Re-submittal Form

Case Name/ Number: VSP2024-00024

PROPOSED DETACHED GARAGE
14620 COLORADO BLVD.
BRIGHTON, COLORADO, 80602

1 SITE PLAN
1" = 30'-0"

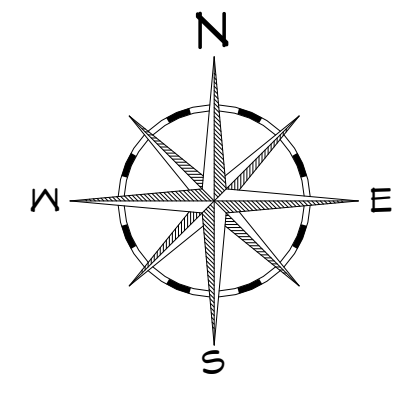
PLN01	Please include an updated site plan that also includes distances of all buildings (existing and proposed) to septic system and leach field. Please see Environmental Review comments for more on this requirement.	The updated site plan includes the distances of all buildings to the septic system and leach field also included is the Onsite System As-Built Drawing from Tri-County Health Dept.
PLN02	Please provide the height and an elevation of the proposed outbuilding, including what type of materials the outbuilding may be constructed out of.	Please refer to the 14620 Building Design document
PLN03	Claps Subdivision plat includes a building envelope for this subject parcel. Applicant is encouraged to minimize variance request to conform to the plat as well as Adams County Development Standards and Regulations in proposing a distance from Colorado Boulevard in reasonably developing the parcel.	The proposed building is within the Claps Subdivision plat building envelope. We have minimized the proposed size of the building and moved it to the East and North to reduce the requested distance for the variance.

ROW3	The Site Plan must provide the location and limits of the leach field and offset to the proposed structure.	Please refer to the updated site plan and leach field drawings from Tri-County

ENV2	If the site is served by a septic system, an updated site plan, to-scale, is required to show the actual location of each septic system component to include tank(s), soil treatment area (leach field), and piping system, location of the proposed building, and horizontal distances in feet between septic components and site features (buildings, property lines, etc.).	Please refer to the updated site plan and leach field drawings from Tri-County
ENV3	Adams County Health Department (ACHD) regulates On-Site Wastewater Treatment Systems, also known as septic systems, through the issuance of permits to install, repair, expand, use, or operate a system. Per ACHD Regulation O-22, setback distances from septic tanks, piping, and soil treatment areas must be maintained for proposed and existing structures. The regulation, including setback requirements, can be found at https://adamscountyhealthdepartment.org/onsite-wastewater-treatment-systems-septic-systems .	We are well within the setback distances from septic tanks, piping. Soil treatment areas are maintained for proposed and existing structures

**Onsite System
As-Built Drawing**

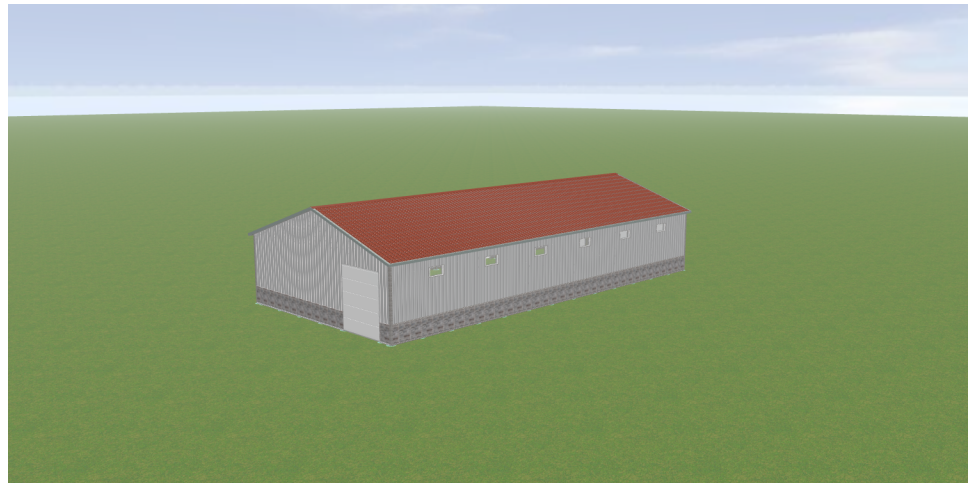
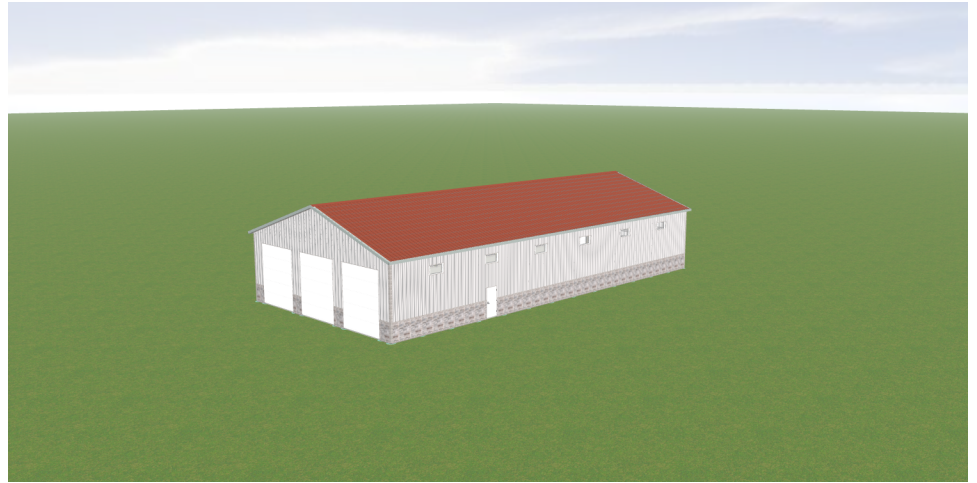
Environmental Analyst Review - Megan Grant		
Resubmittal Required		
ENV1	Please provide proof of sewer service, as required by the application.	We have a septic system, please review the leach field drawings from Tri-County
